HISTORIC AND DESIGN REVIEW COMMISSION

October 17, 2018

HDRC CASE NO: 2018-512
ADDRESS: 1650 E PYRON AVE
LEGAL DESCRIPTION: NCB 7650 BLK LOT 25 AND 26
ZONING: R-6, H
CITY COUNCIL DIST.: 3
DISTRICT: Mission Historic District
APPLICANT: Michael & Cynthia Matson
OWNER: Michael & Cynthia Matson
TYPE OF WORK: Window replacement, fenestration modifications
APPLICATION RECEIVED: September 25, 2018
60-DAY REVIEW: November 24, 2018
REQUEST:

1. Replace the existing, aluminum windows with windows.
2. Modify two window openings on the front façade for bedroom egress on the front façade and one bedroom window on the rear façade.

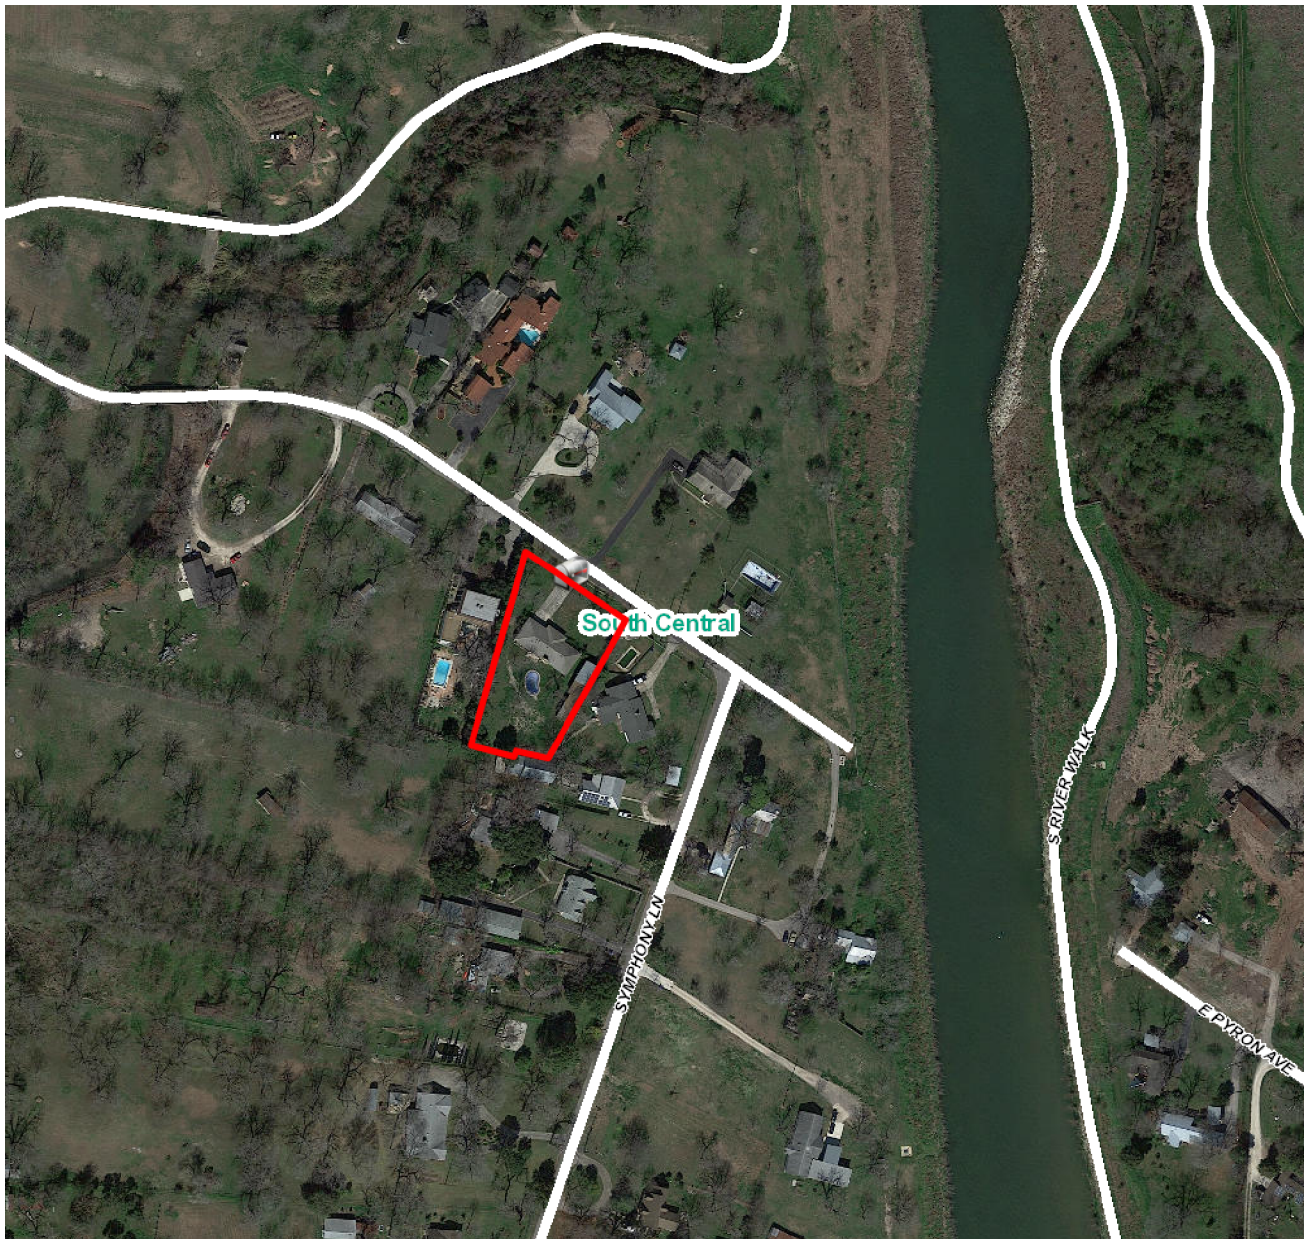
- c. **WINDOW MODIFICATIONS (front façade)** – The applicant has proposed modifications to the front façade’s fenestration that includes a modification from two existing horizontally oriented windows to two, one over one windows measuring approximately three (3) feet in width and six (6) feet in height. While a change from the original fenestration profile, one over one window profiles are typical for the architectural style of the house. Staff finds the proposed modifications to be appropriate. Staff finds that the one over one windows should only modify the portion of the windows that matches the new width. The original, narrow window profiles to the right and left of each should remain as they currently exist.

- d. **WINDOW MODIFICATIONS (rear façade)** – The applicant has proposed to modify an existing, rear window opening by installing French doors. Staff finds that the proposed modification is not visible from the right of way and is generally in keeping with the architectural style of the house.

Staff recommends approval based on findings a through d with the following stipulations:

- i. That brick match the original in any in-filled locations and that the proposed cedar or wood shake shingles be comparable in size to those that currently exist (to the left and right of the dining room window openings).
- ii. That the one over one windows should only modify the portion of the windows that matches the new width. The original, narrow window profiles to the right and left of each should remain as they currently exist.
